TRANS/WP.29/GRSG/60  
21 December 2001

REPORT OF THE WORKING PARTY ON GENERAL SAFETY PROVISIONS (GRSG)  
ON ITS EIGHTY-FIRST SESSION

(8 to 11 October 2001)

Model A

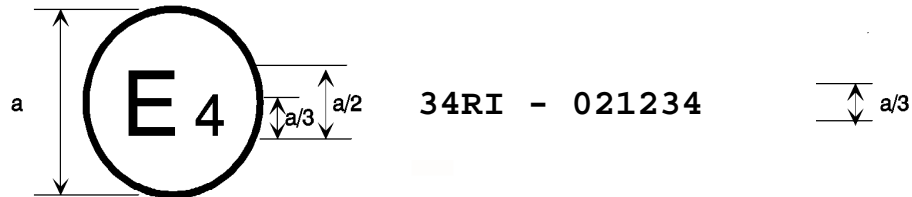
Annex 2, amend to read:

The above approval mark affixed to a vehicle shows that the type concerned was approved in the Netherlands (E4) pursuant to Part I of Regulation No. 34 under approval No. 021234. The first two digits (02) of the approval number indicate that the approval was granted in accordance with the requirements of Regulation No. 34 as amended by the 02 series of amendments.

Model B

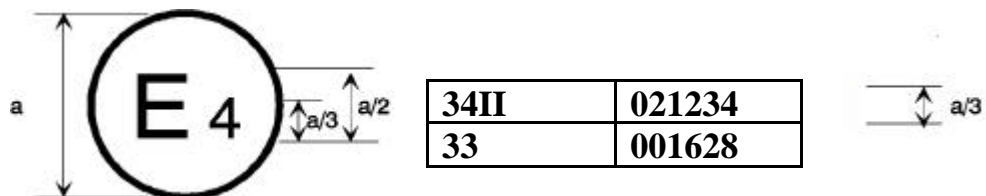
The above approval mark affixed to a vehicle shows that the type concerned was approved in the Netherlands (E4) pursuant to Regulations Nos. 34 Parts I and II and 33 \*/. The approval numbers indicated that, at the date when the respective approvals were given, Regulation No. 34 included the 02 series of amendments and regulation No. 33 was still in its original form.
